## Determination 2007/140

### Determination regarding a covered walkway at New Plymouth Airport, 192 Airport Drive, New Plymouth

Figure 1: Typical section through walkway

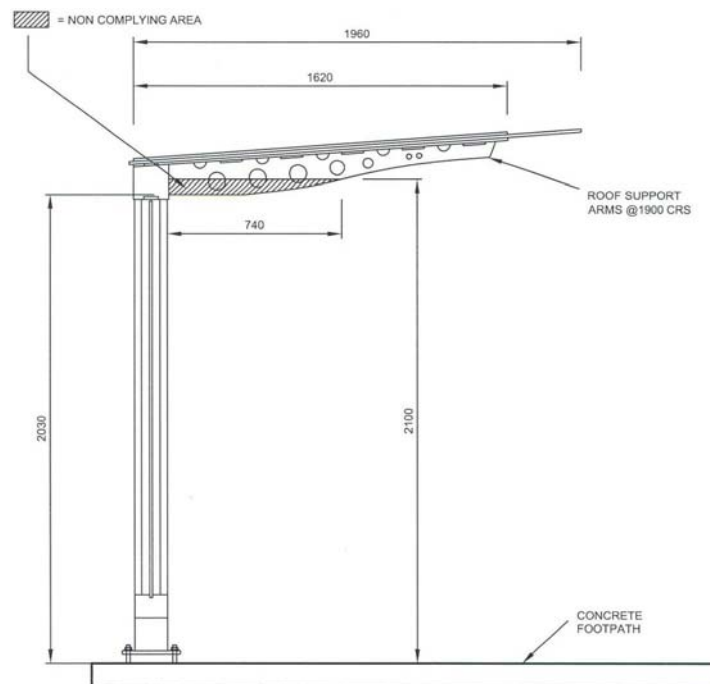
STEEL STRUCTURE SUPPORTING GLAZING IS REQUIRED TO HAVE A MINIMUM CLEAR HEIGHT OF 2.100M TO FINISHED GROUND LEVEL NOT 2.00M AS SPECIFIED [Design and build supplier] DRAWINGS.

5.3 The sectional drawing supplied by the applicant shows that for a horizontal distance of 740mm, measured from the face of the vertical glazing bars in the wall, the vertically raked roof support arms are from 2030mm to 2100mm above the finished ground level. Beyond that 740mm distance, the roof supports continue to rake upwards and the distance to the finished ground level exceeds 2100mm by an increasing amount.

- 5.4 I note that the 2030mm dimension shown in the sectional drawing described in paragraph 5.1 is at variance with the 2000mm cited in the notice to fix issued on 1 June 2007, and is based on the design and build supplier's drawings.

- (b) Be free from dangerous obstructions and from any projections likely to cause an obstruction.
- 5.6 I consider I am being asked to determine whether the roof support frames being as low as 2030mm at their lowest point safeguards people from injury as they walk along the paved ground protected by the glazed roofs.

- 5.9 Figure 4 in D1/AS1, to which the applicant refers in his letter dated 26 October 2007, depicts a corridor, rather than a covered walkway open on one side. The minimum height of 2100mm specified in an enclosed corridor is a safe minimum in that situation. An open walkway can reasonably have a lower height over part of its width. The headroom along the walking path at, say, 400mm from the glazed wall, would be about 2065mm.

- 5.10 I conclude that the small reduction in the height of the roof support frames, of about 35mm on the walking path, does not prevent these particular roofs from complying with Clause D1 of the Building Code. I note here that the majority of the length of each frame, and the raked roof glazing above, exceeds the height dimension of 2100mm specified in D1/AS1.

- 6.1 In accordance with section 188 of the Building Act 2004, I hereby determine that the covered walkway does comply with Clause D1 of the Building Code. Accordingly, I reverse the territorial authority's decision to issue a notice to fix.
